## Field Safety Notice

### Invacare® Birdie® EVO Lifter - alert for the correct attachment of the Sling Loops on the Spreader bar Hooks

Ref: FSN-Birdie EVO-20191016

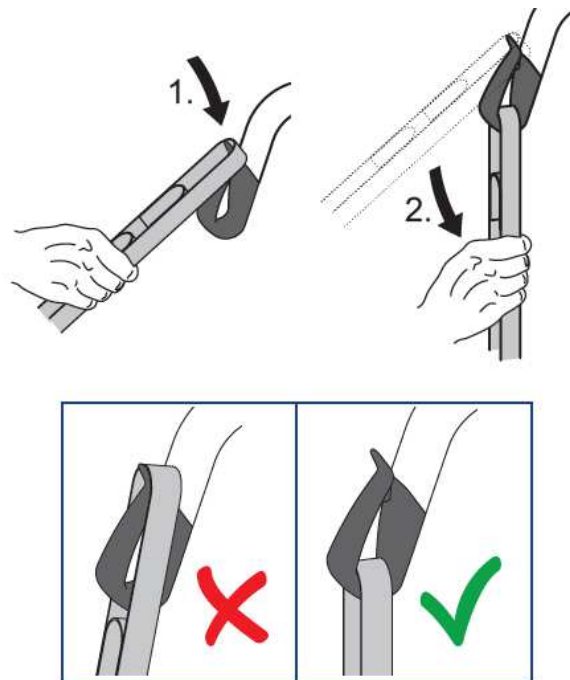
In detail, it is important to place the sling loops on the lifter's spreader bar hooks as visualized in below **picture 2**. Therefore, the sling loops need to be pulled completely down on the hooks. This removes any risk of unintended sling loop detachment.

If the sling loops are wrongly placed on the hook's lip, as shown on **picture 1**, there is a risk of unintended sling detachment.

PICTURE 1 – WRONG SLING LOOP ATTACHMENT

PICTURE 2 - CORRECT SLING LOOP ATTACHMENT

The User Manual and Quick Guide are updated accordingly to show in a more visualized way the **correct attachment of the sling loops on the spreader bar hooks** - pictures below. Also, an example of wrong attachment is given:

Additionally, a **new adhesive label** is created to be placed on the spreader bar above each hook, to alert and inform the customers of the correct attachment of the sling loop – picture below:
